PCN-20200818 KK0807-02 to KK0807-02A Hardware Revision Change

Company	Trenz Electronic GmbH
PCN Number	PCN-20200818
Title	KK0807-02 to KK0807-02A Hardware Revision Change
Subject	Hardware Revision Change
Issue Date	2020-10-02

Affected Product	Replacement
KK0807-02	KK0807-02A

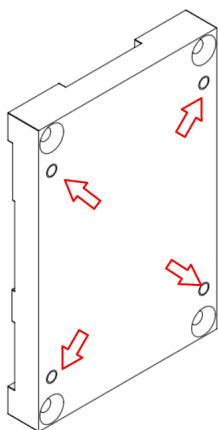
#1 Added four M3 mountig holes.

Type: Hardware change

Reason: Request for screwed mounting of cooler on heatspreader.

Impact: The heatspreader is compatible with cooler KK0001-01.

Models with 4 additional threads are revision 02A.
